PCN Number:	20140107000	PCN Date:	01/24/2014
--------------------	-------------	------------------	------------

Title: Conversion to smaller reel (13" to 7") and associated packing materials on Selected QFN Devices currently shipped in 13" reels

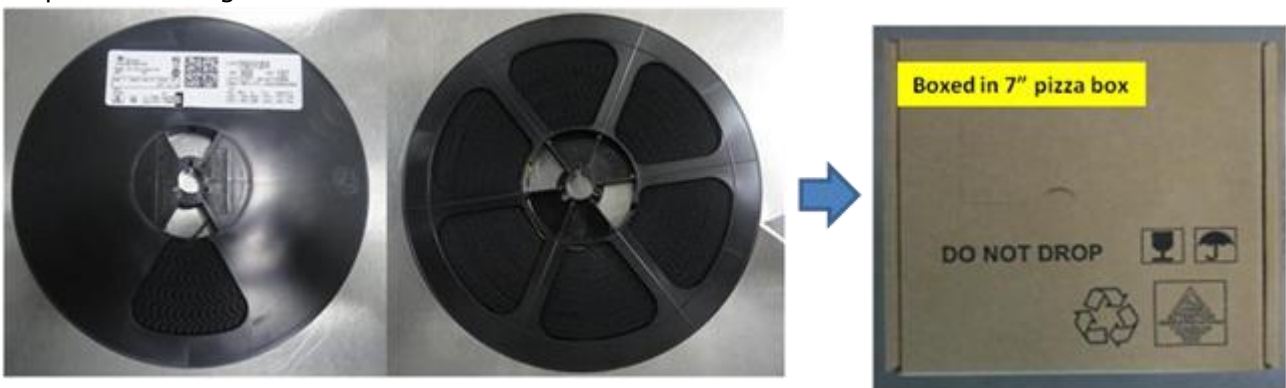
Conversion to a smaller reel size for selected product currently shipped in 13" reels with small reel quantities. The Moisture Barrier Bag (MBB) and pizza box will be switched to accommodate the smaller reel size. All new packing materials are qualified and currently in use for other products. Pack material differences are shown below:

Current Packing – 13 inch reel diameter

Proposed Packing – 7 inch reel diameter

Pack BOM	From	To
Reel Diameter	13"	7"
Pizza Box	4041330	4206831
